**E-54 Regional Lift Station - RFCSP
Solicitation Number: CO-00537
Job No.: 22-2502**

**ADDENDUM 5
November 2, 2022**

SAWS JOB NO. 22-2502
JOB NO. 11500-51
DATE MAY 2022
DESIGNER J.H.
CHECKED S.J.F., DRAWN S.J.F.
SHEET **S1.0**

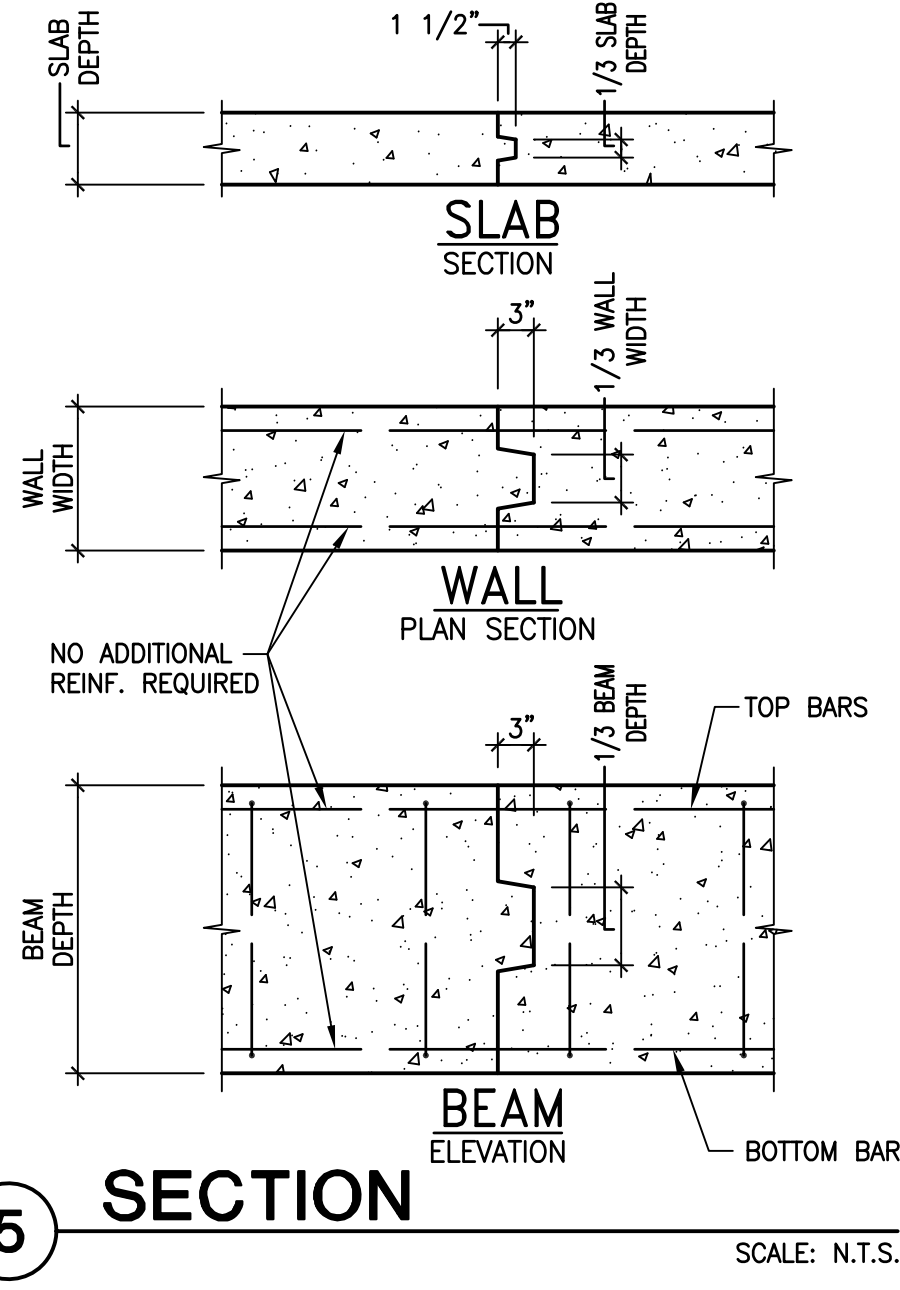
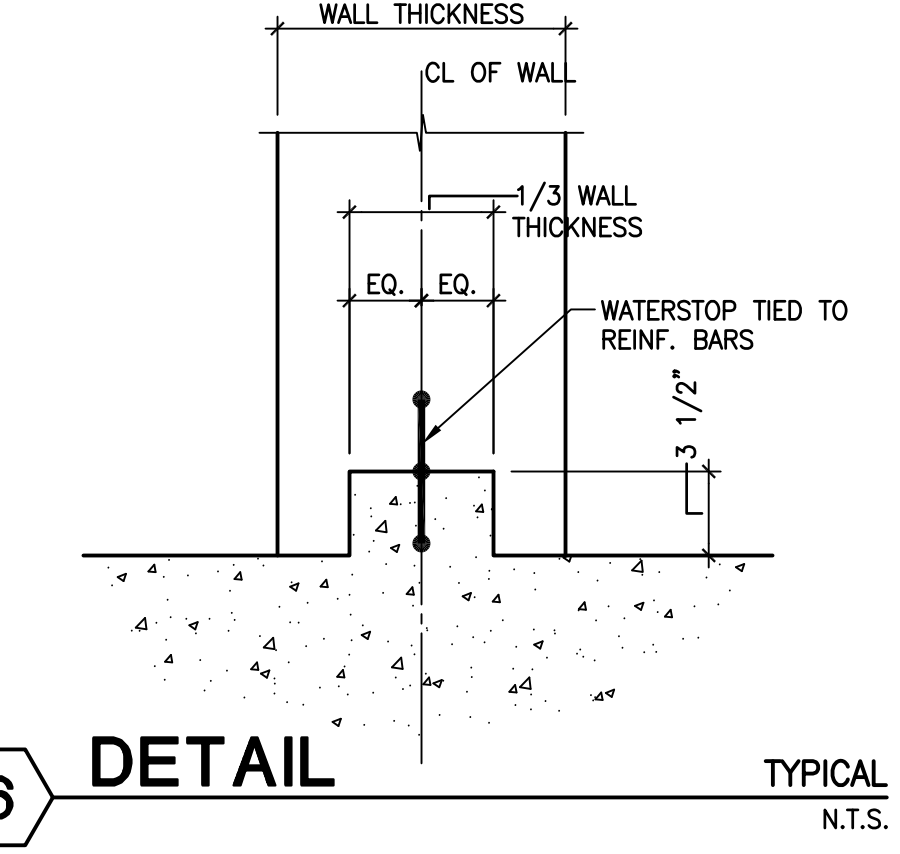
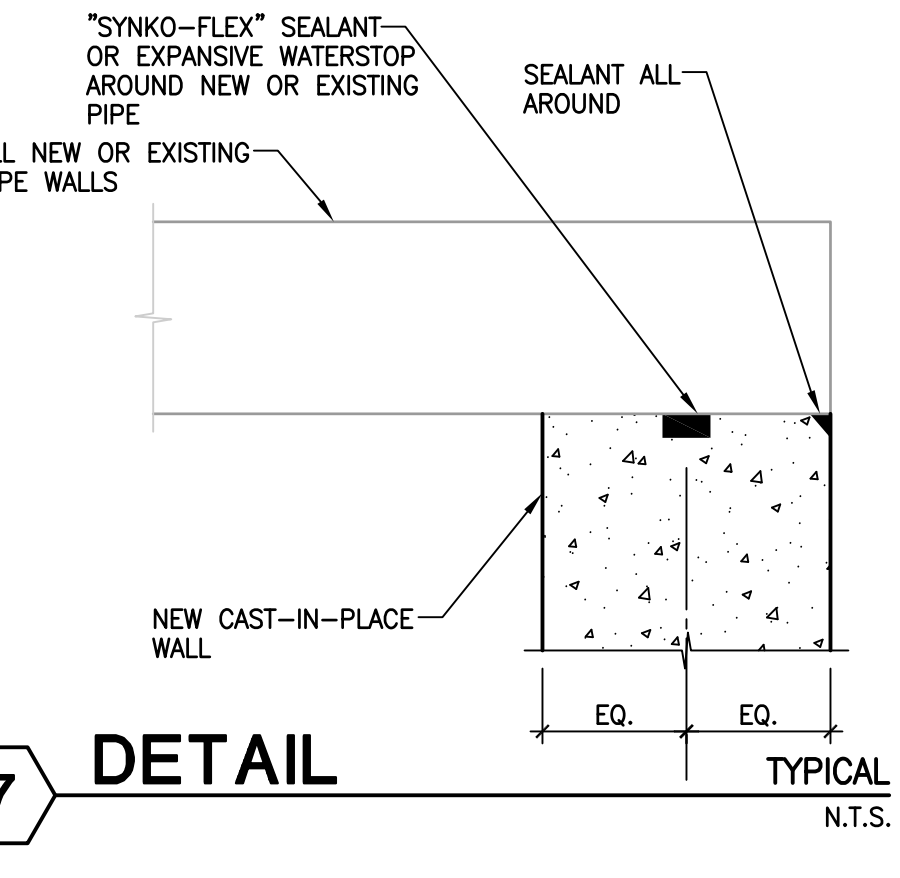
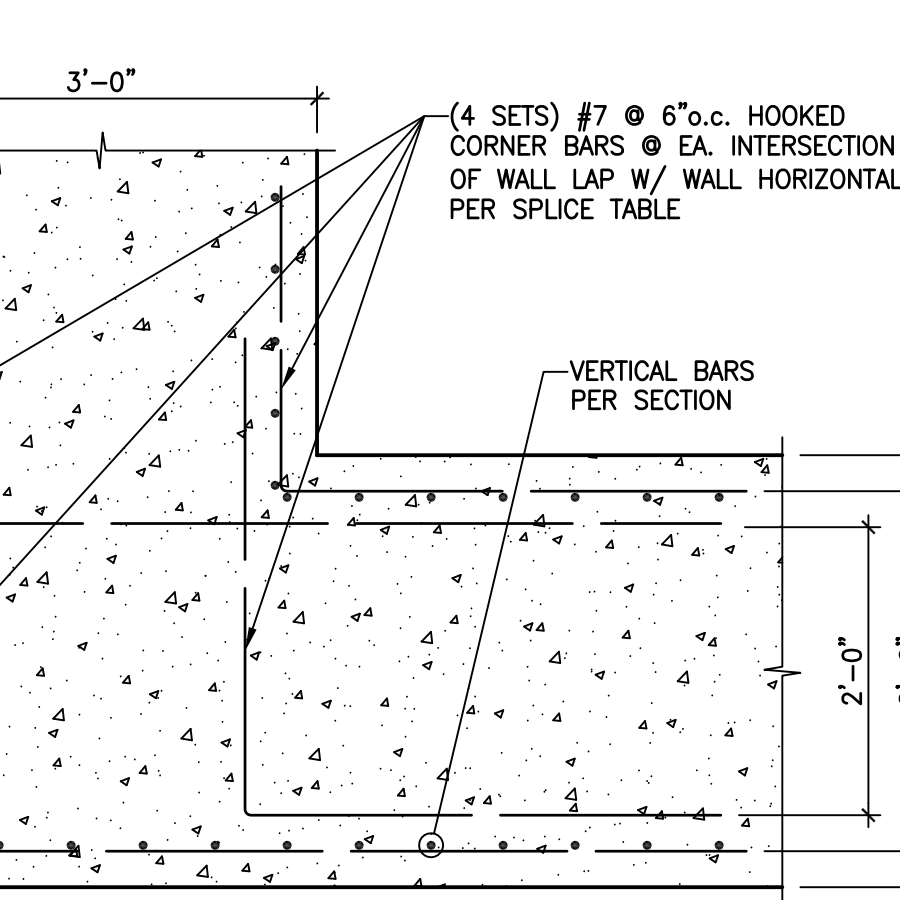
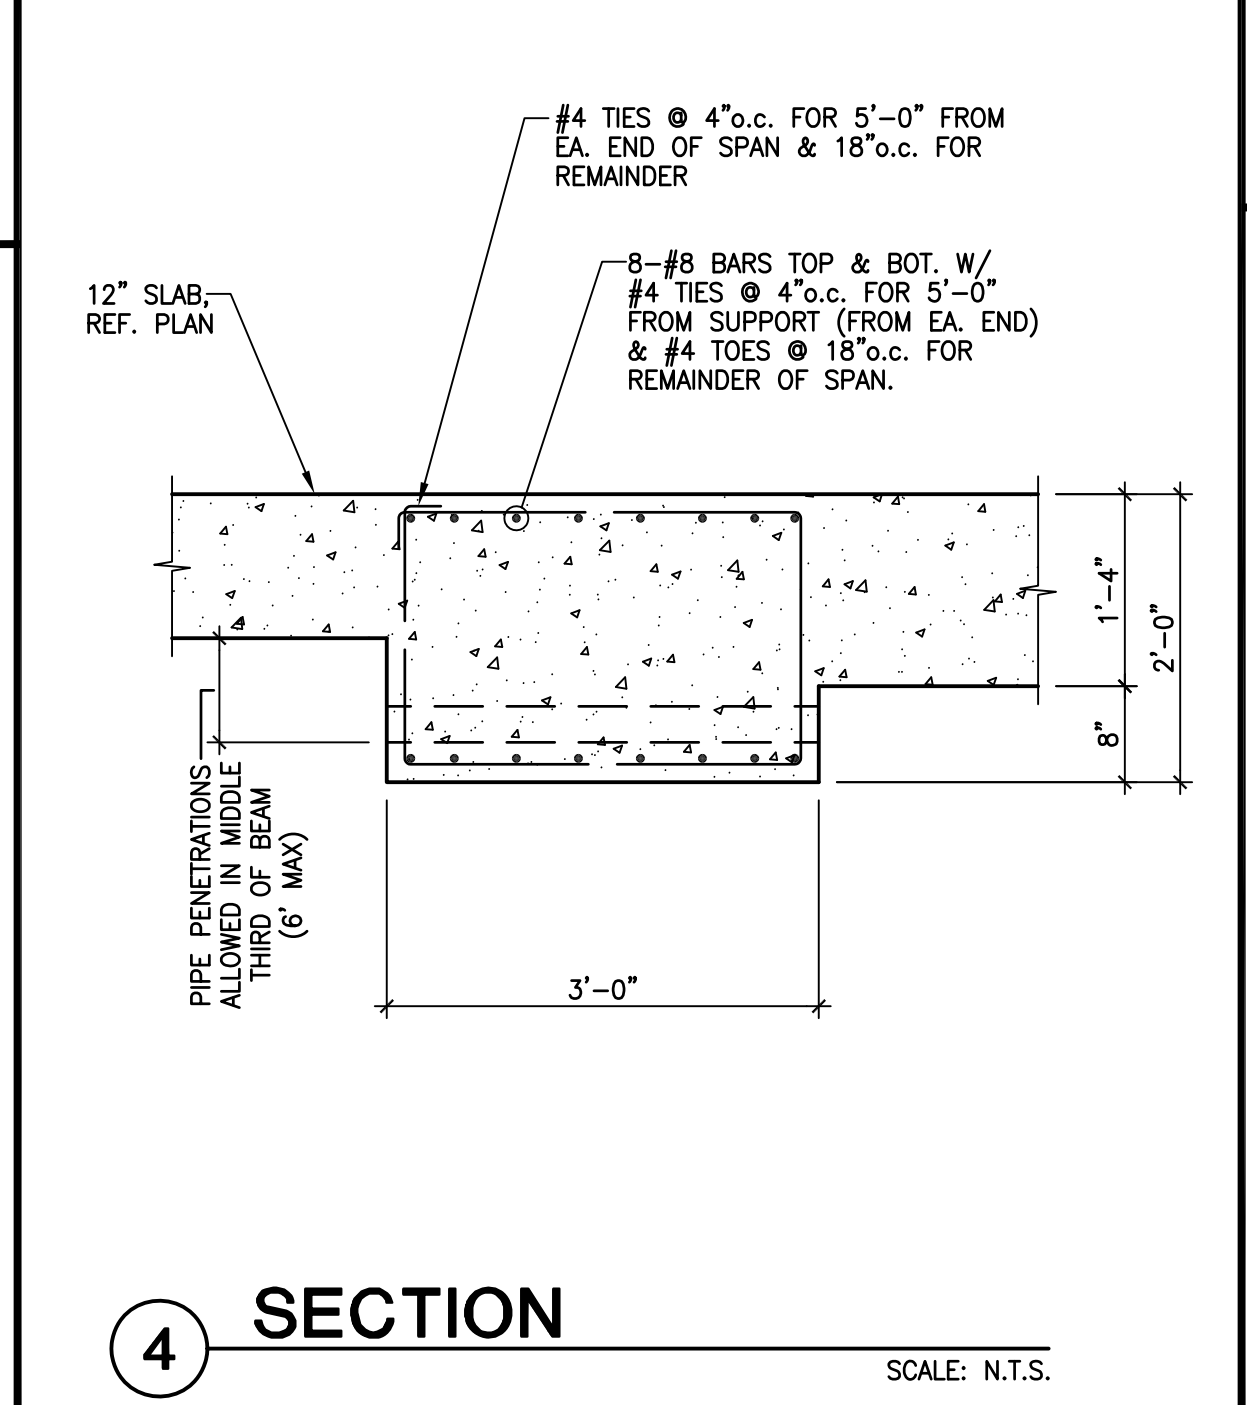
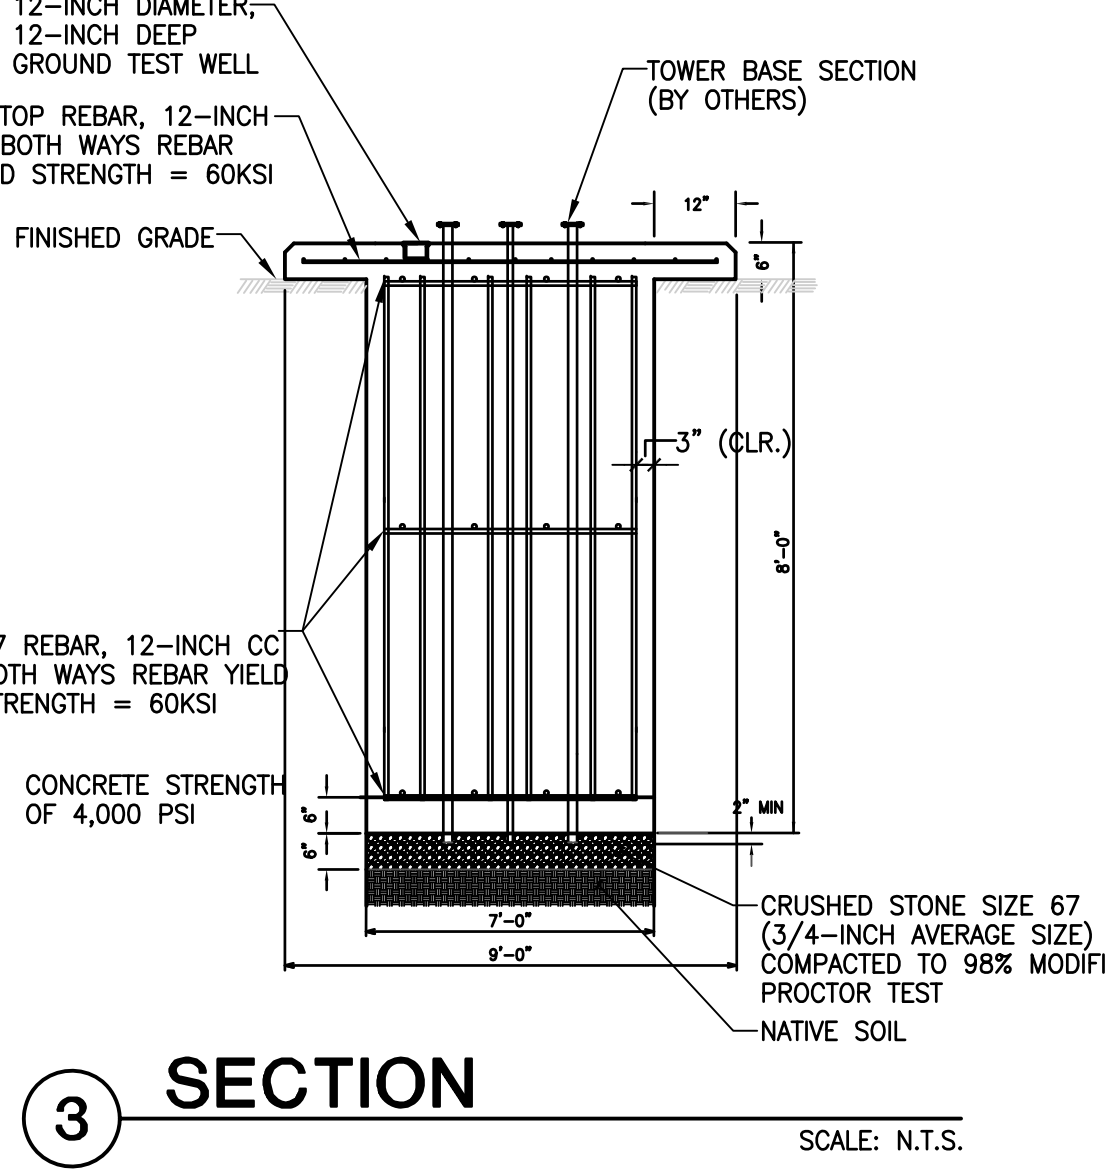
Approximate 774 Sf of slab is called out as 8” thick, but no rebar details.

Slab is called as 12" thick without rebar details.

RESPONSE: Revised the detail to show the reinforcing on the slab and have clarified the slab reinforcing within the FN-Notes on S1.0 to reflect 8" slab. Sheet S1.0 – Notes, Sections, and Details revised and attached in this Addendum. Please see Changes to the Plans #2.

RESPONSE: 12" slabs were remnant of previous iteration of design and are no longer present in this project. Refer to FN-Notes on S1.0 for all applicable slab sizes. See response to Question 4 in this Addendum.

SAWS JOB NO.	22-2502
JOB NO.	11500-51
DATE	MAY 2022
DESIGNER	J.H.
CHECKED S.J.F.	DRAWN S.J.F.
SHEET	S2.1

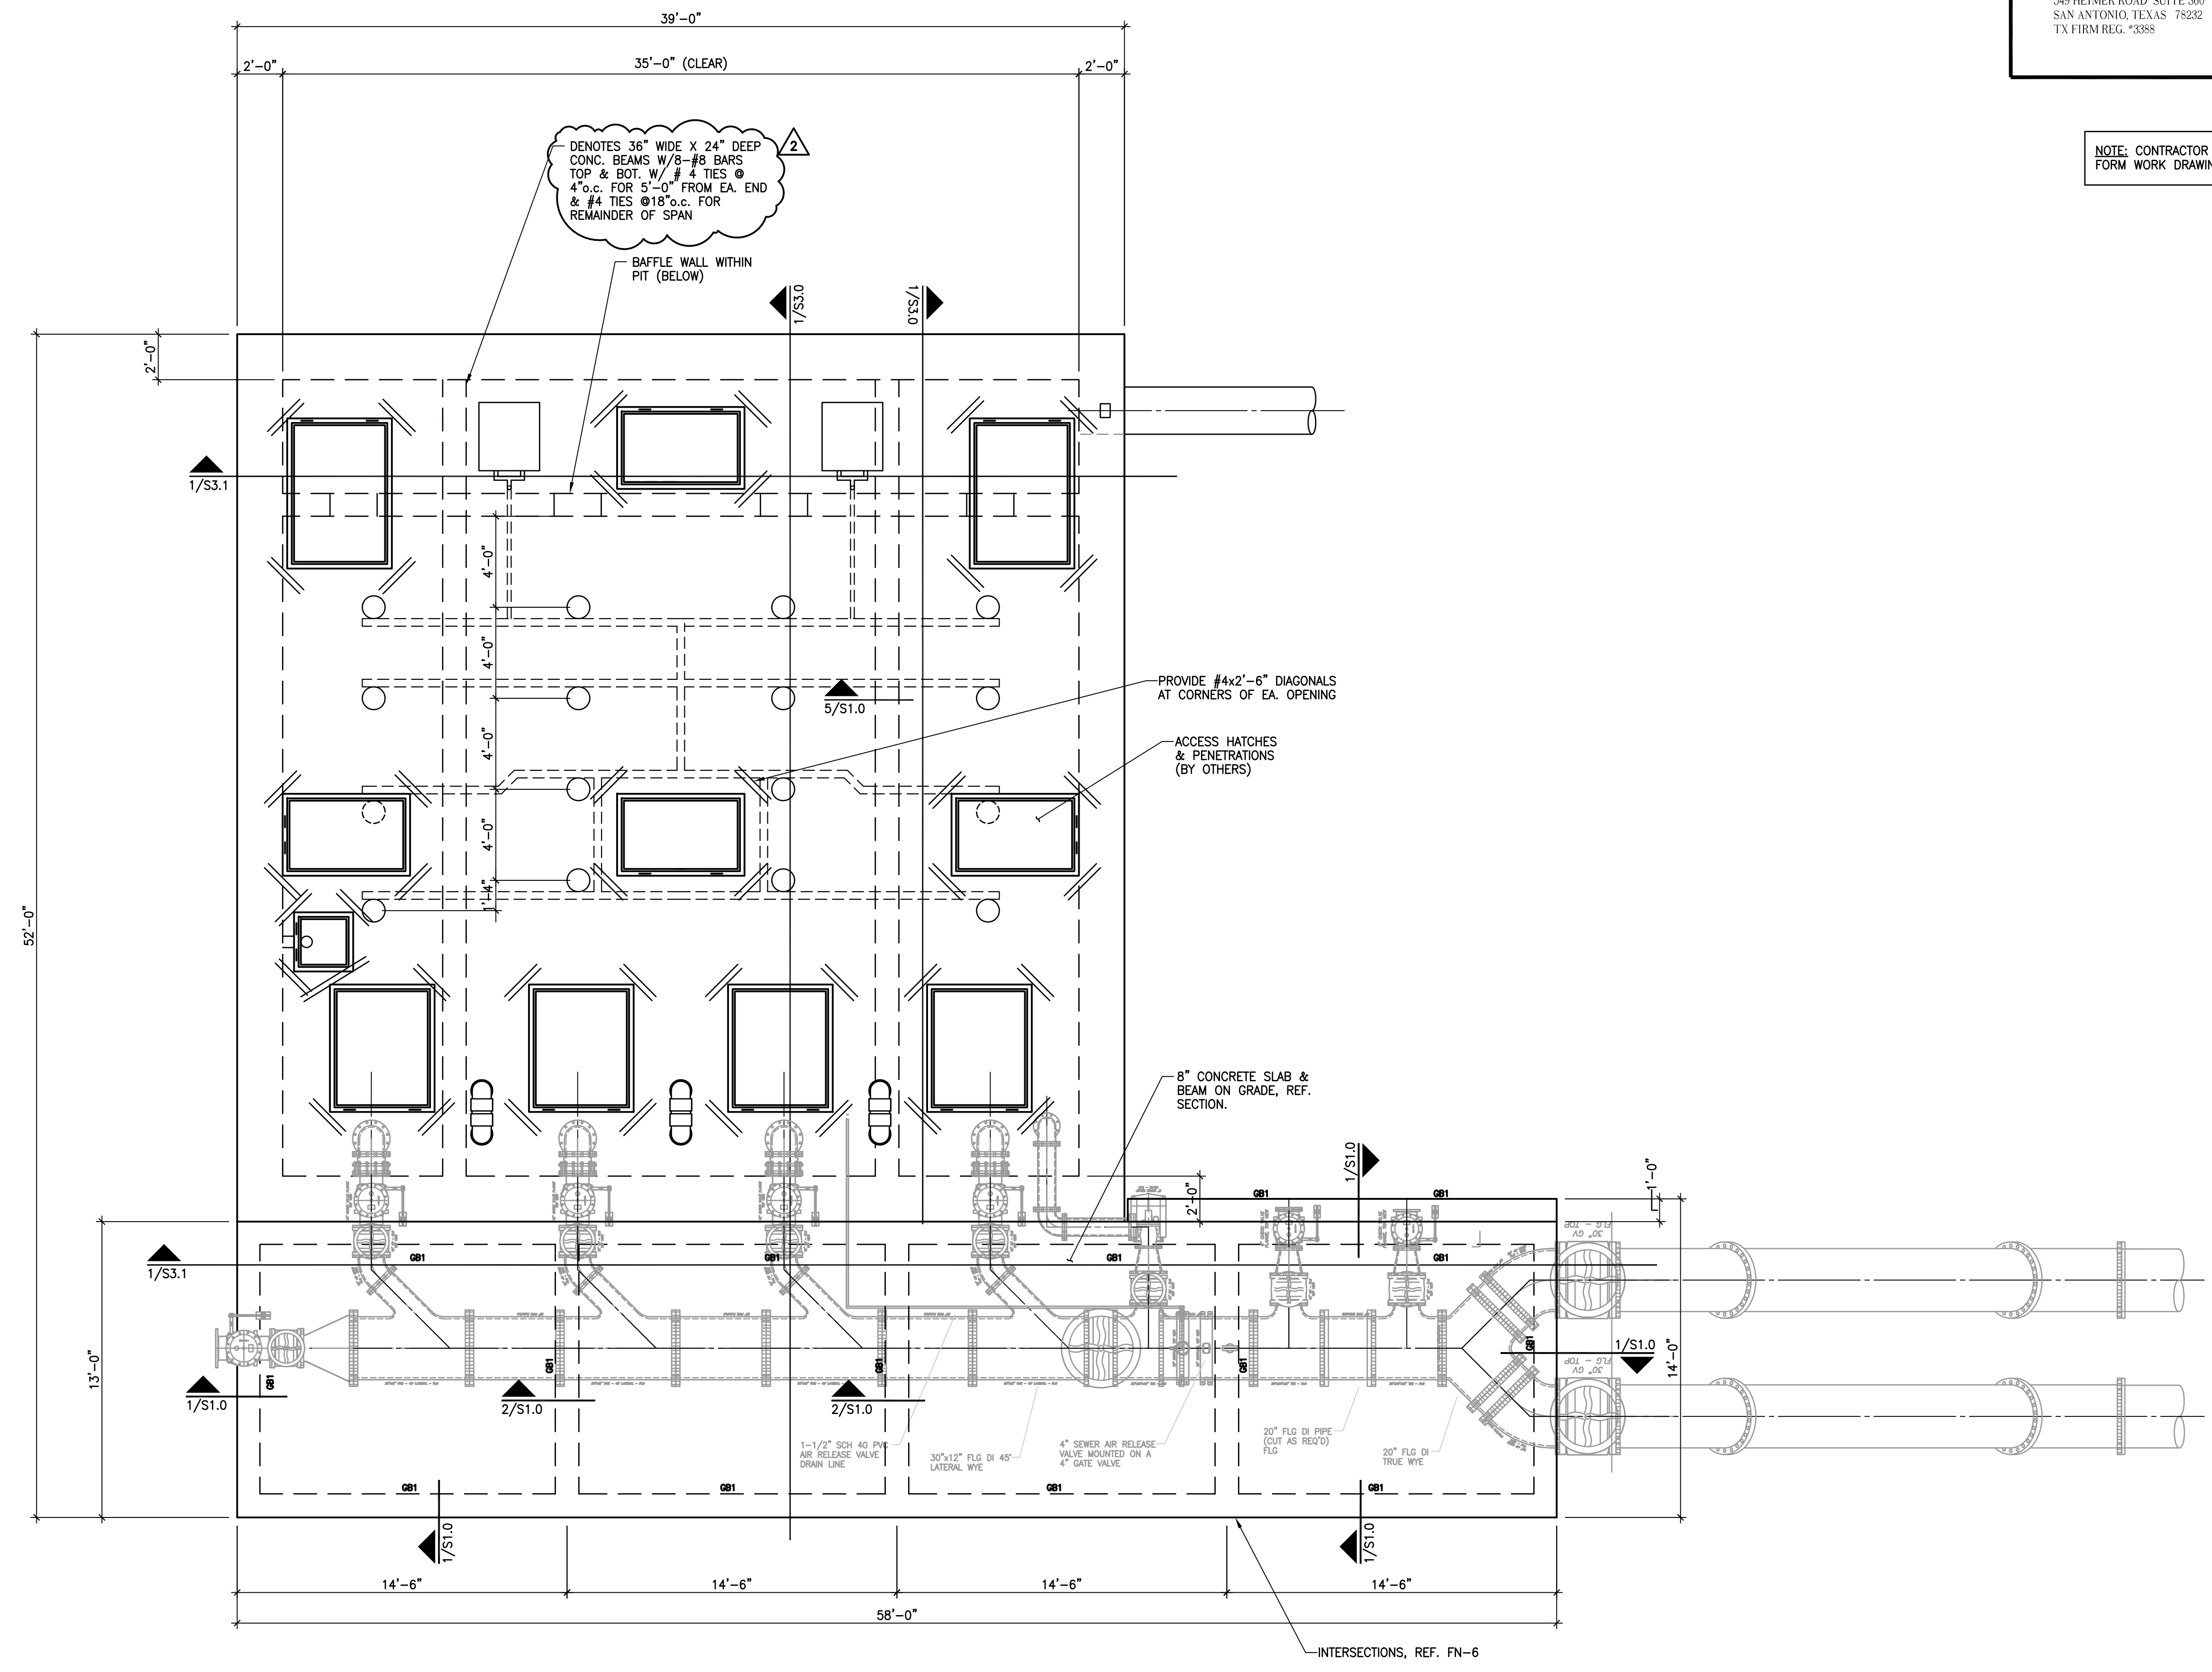
On Sheet S2.1, beams are called out as 24” x 24”, but reference detail shows 36” x 24”. I am planning to use 36” x 24”.

RESPONSE: The beam is intended to be 36”x24”. The text on Sheet 2.1 was a typo. Sheet S2.1 – Wetwell Grade Level Plan is revised and attached in this Addendum. Please see Changes to the Plans #3.
